Docket Number:	15-RETI-02
Project Title:	Renewable Energy Transmission Initiative 2.0
TN #:	211487
Document Title:	Bay Area Municipal Transmission Group's Comments on the Renewable Energy Transmission Initiative 2.0 May 2, 2016 Workshop
Description:	N/A
Filer:	System
Organization:	Bay Area Municipal Transmission Group
Submitter Role:	Public Agency
Submission Date:	5/16/2016 8:42:31 AM
Docketed Date:	5/16/2016

Bay Area Municipal Transmission Group's Comments on the Renewable Energy Transmission Initiative 2.0 May 2, 2016 Workshop

Bay Area Municipal Transmission Group's Comments on the Renewable Energy Transmission Initiative 2.0 May 2, 2016 Workshop

May 16, 2016

Figure 1: New Renewable Capacity in San Joaquin Valley¹²

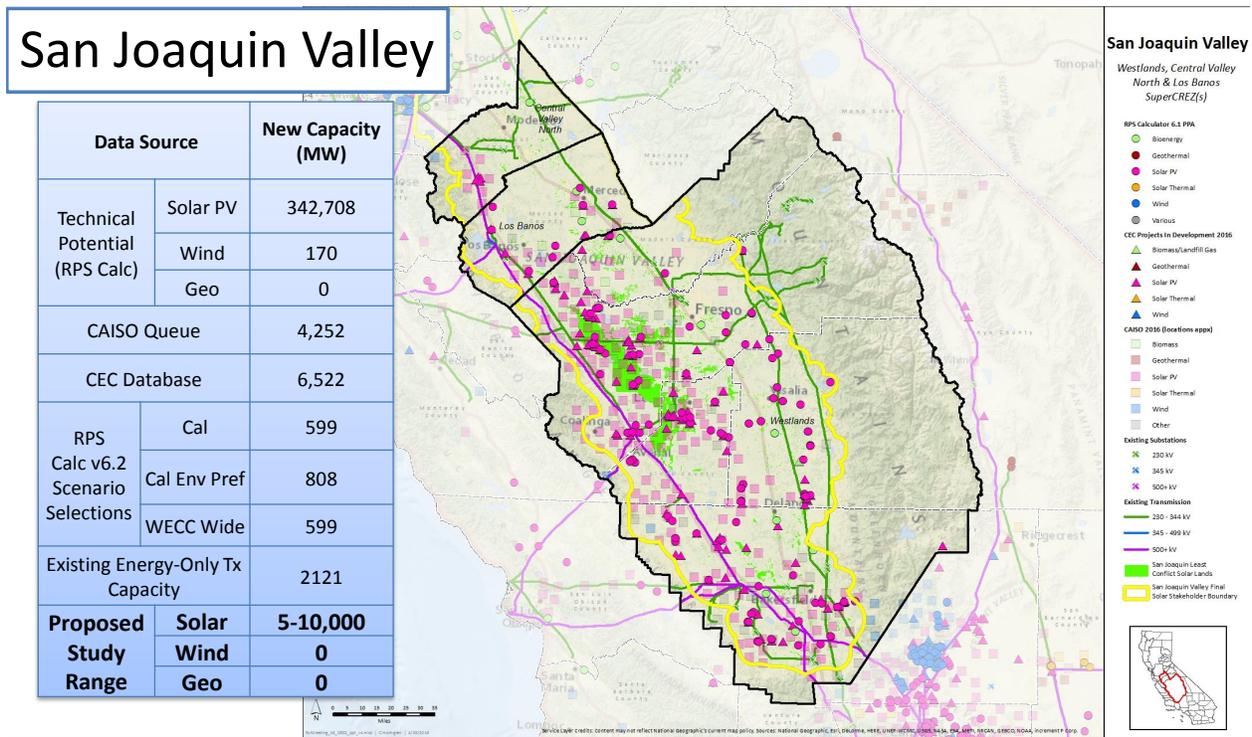
for problems that do not exist, which is a significant departure from “least regrets” solutions. For instance, Figure 1 that was presented during the May 2nd workshop shows that there is currently 4,252MW of renewable capacity located in the San Joaquin Valley area in the CAISO generation interconnection queue. It is well-known that the currently active capacity (more than 30,000MW) in the CAISO queue¹⁰ is unrealistically high and that a vast majority of that capacity will never materialize because the State does not need that level of renewable capacity to meet the RPS goals. The CPUC RPS Calculator v. 6.2 adds only 599MW to 808MW of renewable generation in the San Joaquin Valley area to meet the 50% RPS goal on a least-cost best-fit basis.¹¹ However, as shown in Figure 1 below, the RETI management team is considering studying 5,000MW to 10,000MW of renewable resources in the San Joaquin Valley. In other words, even the lower bookend of the study range is higher than the extremely high amount of renewable capacity that is currently queued in the San Joaquin Valley. There are better ways to spend scarce RETI 2.0 resources than to postulate development scenarios that are unrealistic.

The above observations made by BAMx in the case of the San Joaquin Valley are also applicable to the other TAFAs included in the California Desert and Northern California.

BAMx suggests that the overarching guideline for determining the renewable capacity study range in a certain area should be the quantity of capacity that will be developed in that area as part of the in-State and OOS renewable mix needed to meet the State’s RPS and GHG goals. Such an approach will likely avoid studying arbitrarily determined renewable capacity (for example, 10,000MW) in a single transmission area, when the overall capacity needed to meet the State goal could be as low as 9,000MW to 15,000MW. BAMx recommends that the RETI management utilize the CPUC Energy Division’s 2016 RPS Portfolio Sensitivities Results¹³ to model the upper limit of renewable resource development in each TAFA. For instance, renewable development in the DRECP/SJVP scenario¹⁴ can be used as a bookend in the Desert area (Tehachapi, Victorville/Barstow, Riverside East, and Imperial Valley) and San Joaquin
